Application No. 10/758,202
Amendment dated November 22, 2005
Reply to Office Action of May 23, 2005

AMENDMENTS TO THE DRAWINGS

FIG. 2

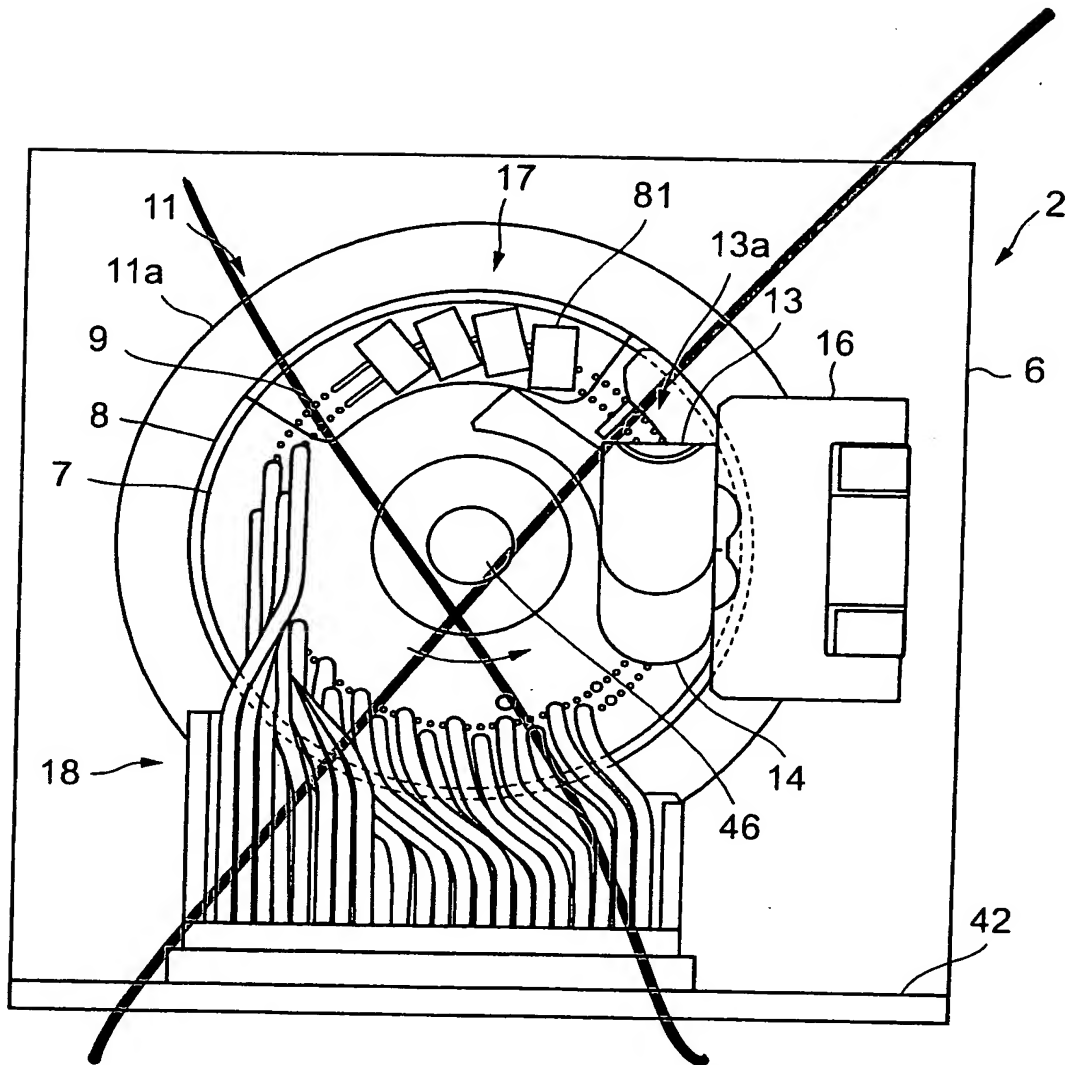
Two (2) sheets of replacement drawings are attached hereto in order to properly label sorting and ejection part 12 and inspection unit 31 in FIG. 2, and to properly show clamp bar 35 and slide groove 35a in FIGS. 11, 12(a), and 12 (b). The two sheets of replacement drawings attached hereto replace Figs. 2, 11, 12(a) and 12(b) as originally filed.

Two sheets of replacement drawings are attached hereto in order to properly label sorting and ejection part 12 and inspection unit 31 in FIG. 2, and to properly show clamp bar 35 and slide groove 35a in FIGS. 11, 12(a), and 12 (b). No new matter has been entered.

FIG. 11

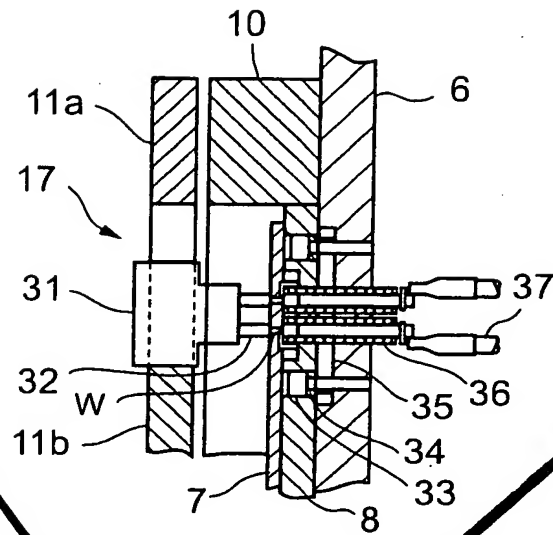
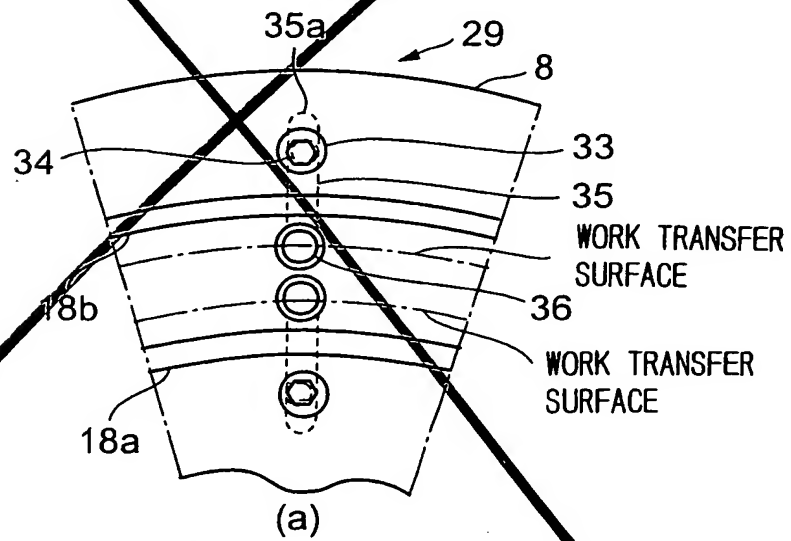
Also, in the interview, the Examiners pointed out that they believed that FIGS 11, 12(a), and 12(b), as originally filed, do not clearly show clamp bar 35 and slide groove 35a. In particular, the Examiners alleged that in the drawings, elements 35 and 35a appear to have the same length, and thus it is hard to tell how clamp bar 35 can slide in slide groove 35a. In response to this objection, revised FIGS. 11, 12(a), and 12 (b) are attached hereto to properly show clamp bar 35 and slide groove 35a, and their relationship to one another.

As is apparent from replacement FIGS. 11, 12(a) and 12(b) the slide groove 35a is longer than the clamp bar 35, and therefore the clamp bar 35 can securely slide in the slide groove when the eccentric cam 34 is rotated.

As is apparent from revised FIGS. 11, 12(a) and 12(b) the slide groove 35a is longer than the clamp bar 35, and therefore the clamp bar 35 can securely slide in the slide groove when the eccentric cam 34 is rotated.
